TCP/11/16(476) – 16/01865/FLL – Formation of access road on land 60 metres East of Kinwreaton, Brucefield Road, Blairgowrie

**PAPERS SUBMITTED
BY THE
APPLICANT**

RE - PKC 16/01865/FLL – PLANNING APPLICATION REFUSAL FOR FORMATION OF ACCESS ROAD AT LAND 60M EAST OF KINWREATON, BRUCEFIELD ROAD, BLAIRGOWRIE

SITE BLOCK PLAN			
New Access Road to Residential Land at Welton Holt, Rosemount, Blairgowrie for Mr & Mrs Bruce & Kirsty Thomson		date 22.10.2016	drawn GD
		scale 1 : 500	revision
		job number 665	drawing number L02
		revision C

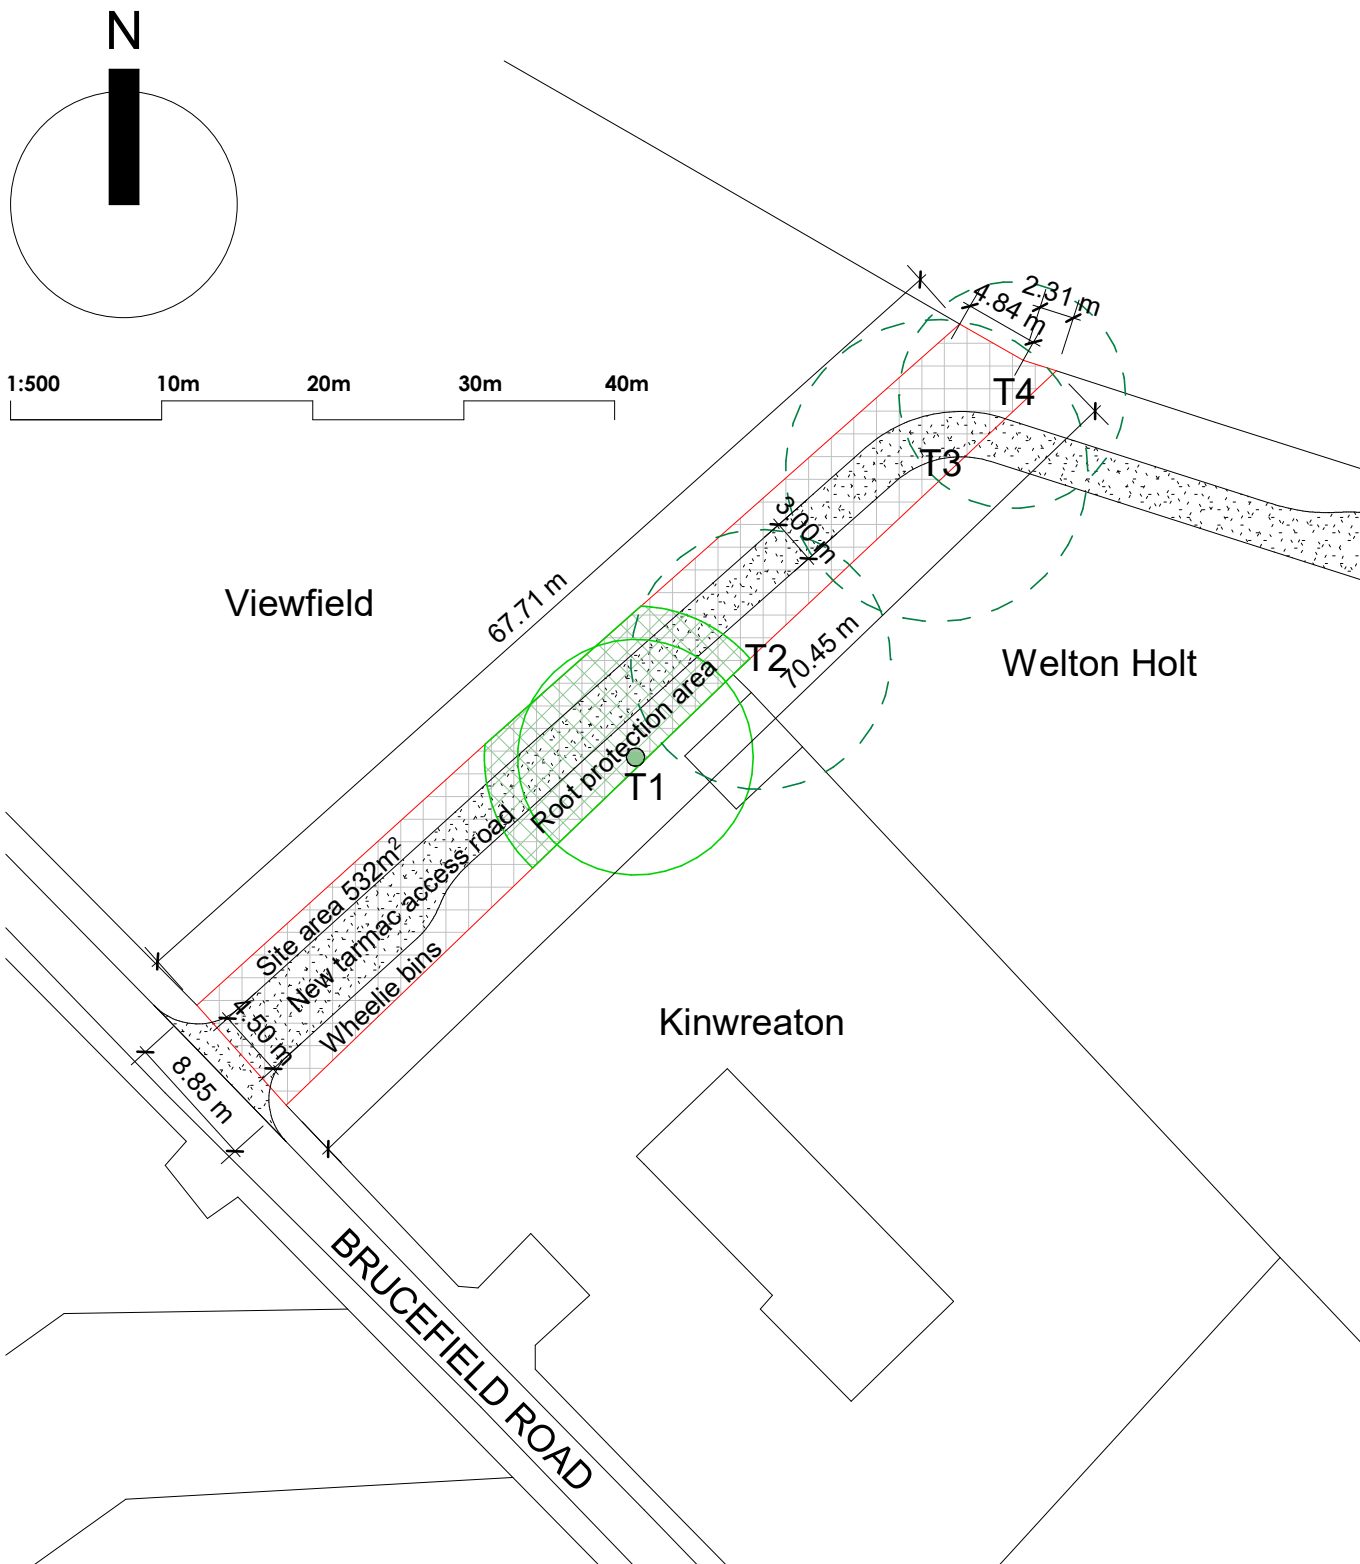
f) The determination took no account of revised drawing 665L03C dated 14.12.2016, prior to determination, which Transport Planning agreed answered much of their consultation response.

9. In the section 'roads and access' there is mention of issues with passing places, road widths and emergency vehicle access. This takes no cognisance of the revised road layout submitted to the planning department and accepted by roads and transports some months prior to the delegated report. Also, it still refers to the 30mph visibility splays of 2.4x46m when Niall Moran Transport Planning Officer had agreed to accept reduced visibility splay of 2x25m. The concern raised about access to housing site H62 could be dealt with in the same manner of the original consent 12/00678/FLL for Mr Thomson's residential site. That required the installation of bollards to prevent vehicular access beyond the site.
